Review of the Far North Solar ‘Preliminary Design’ plans for the predator-proof reserve area (invertebrate reserve) and lizard habitat enhancement area

Warren Chinn
Technical Advice
Invertebrate ecology
June 15, 2026

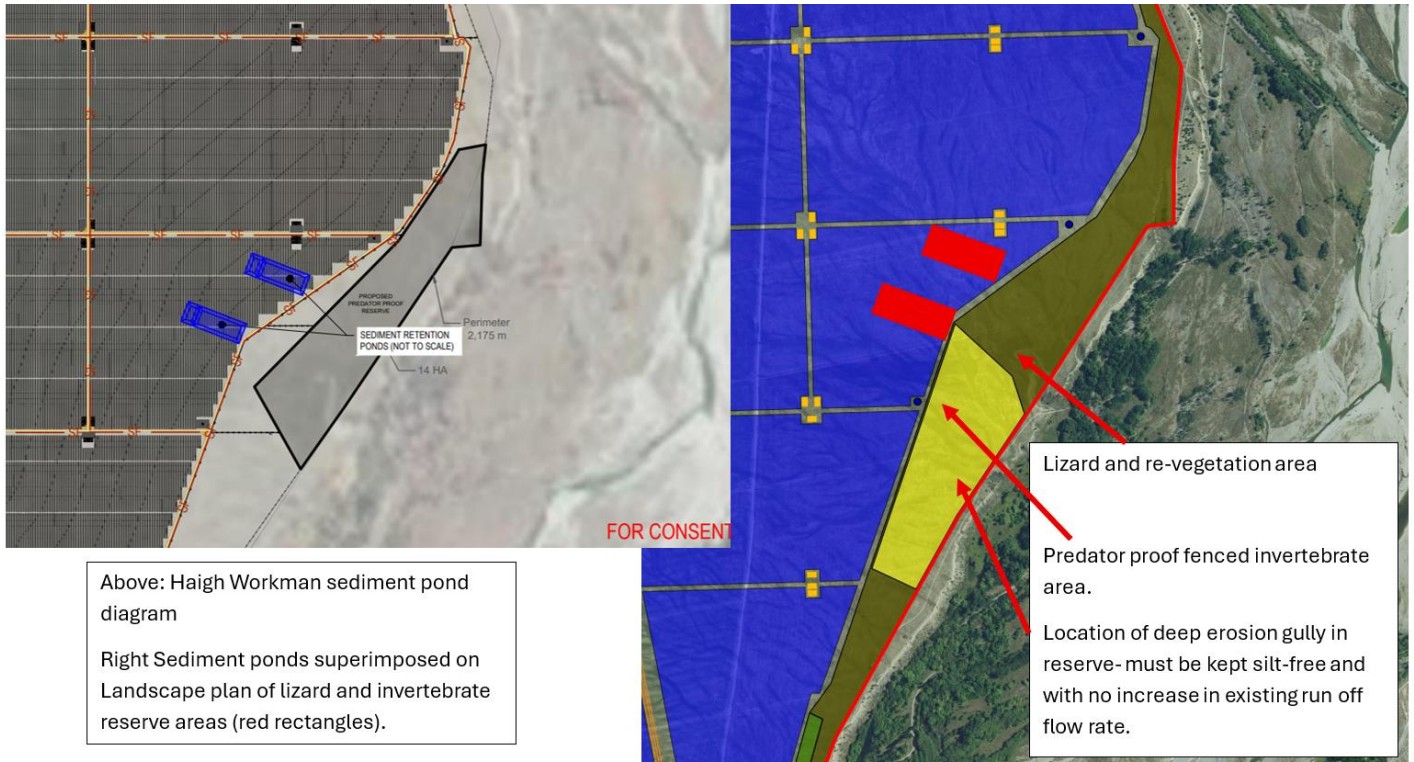
This was a useful document because it provides information about silt and soil control during the solar farm construction. On sheet 1 of the sediment plan, the location of two silt ponds is shown, immediately adjacent and up-slope of the proposed lizard and invertebrate reserves. I have concerns about the location, duration and effects of the sediment control ponds on the (proposed) reserve habitat. I have produced a diagram (below) showing the two plans, side-by-side and the location of the silt ponds and reserves.

In my view, the silt ponds may be in conflict with the reserve areas, particularly in regard to the single, deep drainage channel within the invertebrate reserve area (second figure). This ‘reserve channel’ will currently have a very low and irregular flow regime, which has cut down through stony outwash gravels such that suitable basking habitat has been produced for rare grasshoppers, should they be introduced to the area.

My concerns are the potential for increased water flow into the dry channel (during solar farm construction) and the potential for additional silt build-up and concentration into the proposed reserve, compromising the habitat, either during or after construction is complete.

I appreciate why the silt ponds are being proposed for that location – it is the obvious outlet for surface runoff, but that could also conflict with the reserve design, fencing and hydrology.

The design and engineering of the invertebrate and lizard reserve could be better coordinated in conjunction with the runoff and hydrology report. At present, it appears the two are unaware of each other and it looks as though there could be some technical and environmental conflict between the position of the sediment retention ponds and the invertebrate reserve.
